# Agenda Item # 1

## SUB-002573-2023

Shannon Heights Subdivision, Resubdivision of Part of Lot 9

- Subdivision approval to create one (1) legal lot of record from one (1) metes-and-bounds parcel.

# DETAIL SITE PLAN

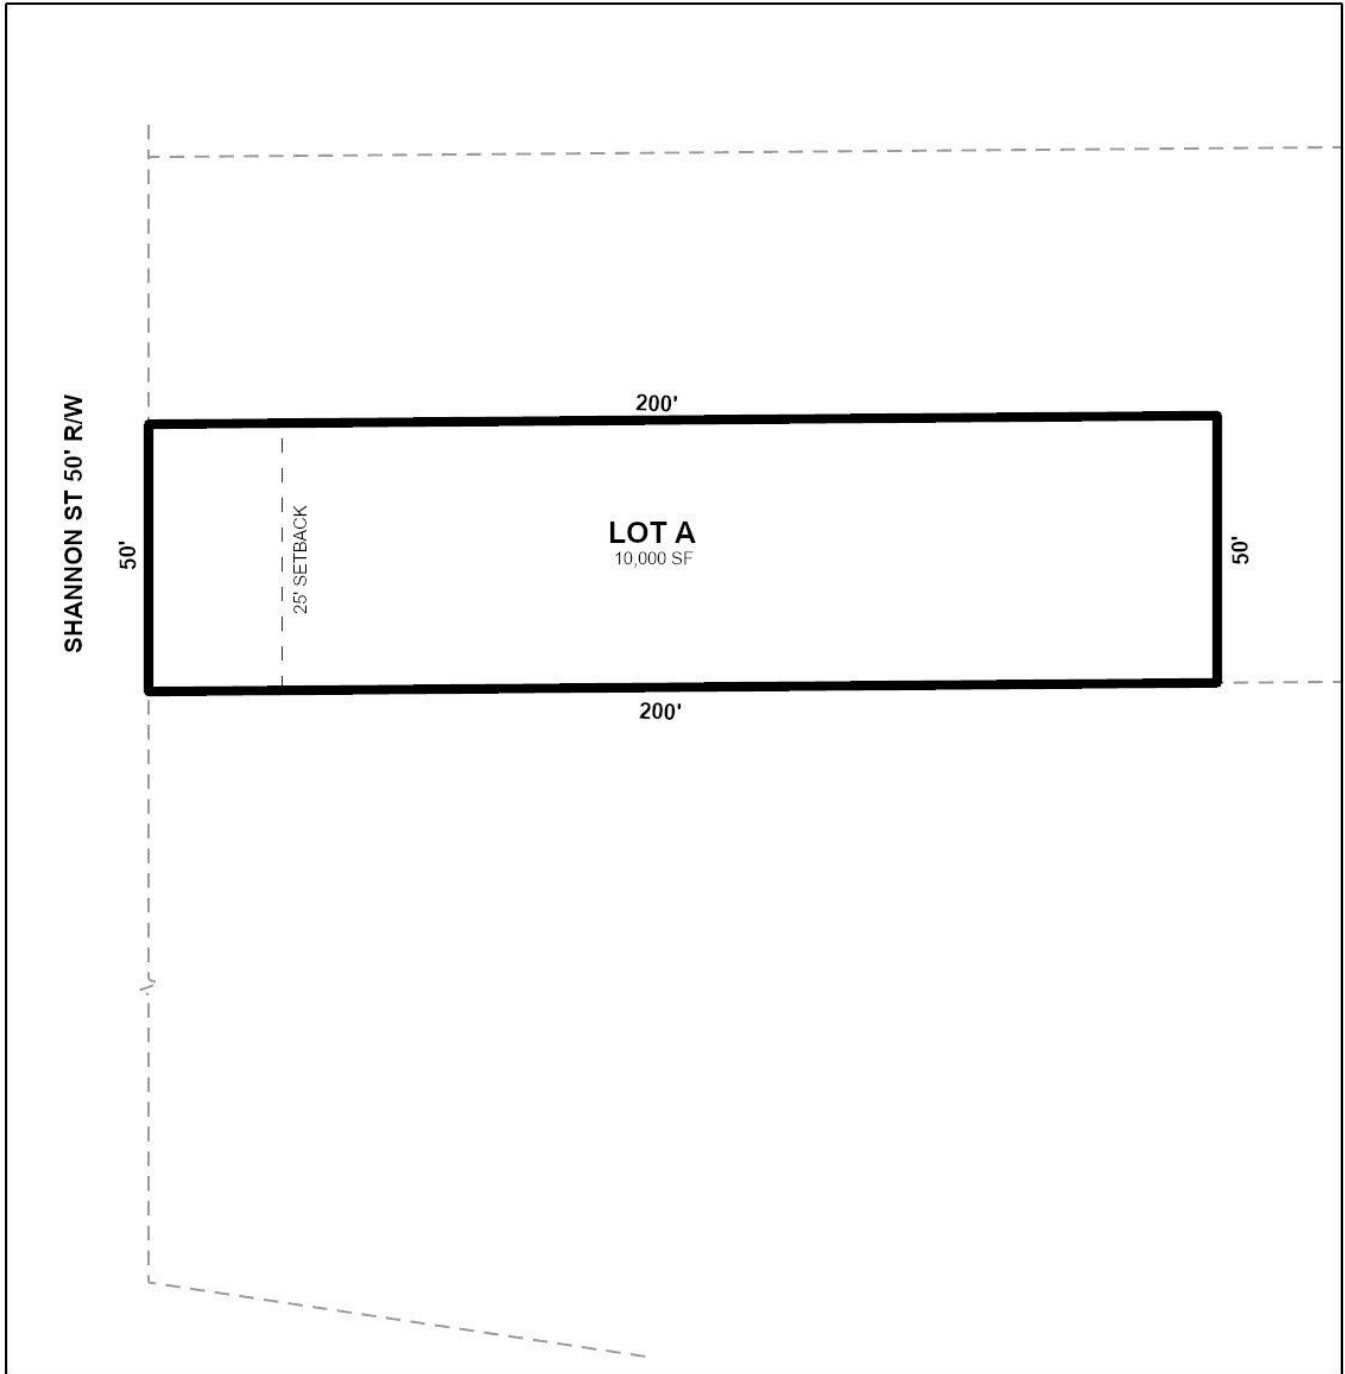
The site has frontage on Shannon Street, a minor street with curb and gutter requiring a 50-foot right-of-way. The preliminary plat illustrates sufficient right-of-way at this location, therefore additional dedication should not be required. If approved, this information should be retained on the Final Plat.

The lot, as proposed, exceeds the minimum size requirements for lots served by public water and sanitary sewer, and is appropriately labeled in square feet and acres; however, the lot's width (50 feet) does not meet the minimum requirements of Section 6.C.2.(b) of the Subdivision Regulations for residential lots within the Suburban sub-district. Furthermore, the lot exceeds the maximum width-to-depth ratio of Section 6.C.3. of the Subdivision Regulations. Such a lot design is not common within the surrounding neighborhood with the exception of the site to the north, which also has a substandard 50-foot width and is 200 feet in length, thus exceeding the maximum width-to-depth ratio of the Subdivision Regulations. The site to the south and most lots nearby are at least 60 feet wide and do not exceed the maximum width-to-depth ratio. Nevertheless, previous development of the site may suggest that a substandard lot width will not negatively impact future development of the property. Moreover, all adjacent lots are developed, which prevents expansion of the lot at this time. As such, waivers of Sections 6.C.2.(b). and 6.C.3. of the Subdivision Regulations may be appropriate.

A 25-foot front yard setback is illustrated along Shannon Street on the preliminary plat, in compliance with Section 64-2-5.E. of the Unified Development Code (UDC). This information should be retained on the Final Plat, if approved.

1. Retention of the 50-foot right-of-way along Shannon Street on the Final Plat;
2. Retention of the 25-foot minimum building setback line along Shannon Street on the Final Plat;
3. Retention of the lot size labels in both square feet and acres, or provision of a table on the Final Plat with the same information;
4. Compliance with all Engineering comments noted in this staff report;
5. Placement of a note on the Final Plat stating the Traffic Engineering comments noted in this staff report;
6. Compliance with all Urban Forestry comments noted in this staff report; and
7. Compliance with all Fire Department comments noted in this staff report.
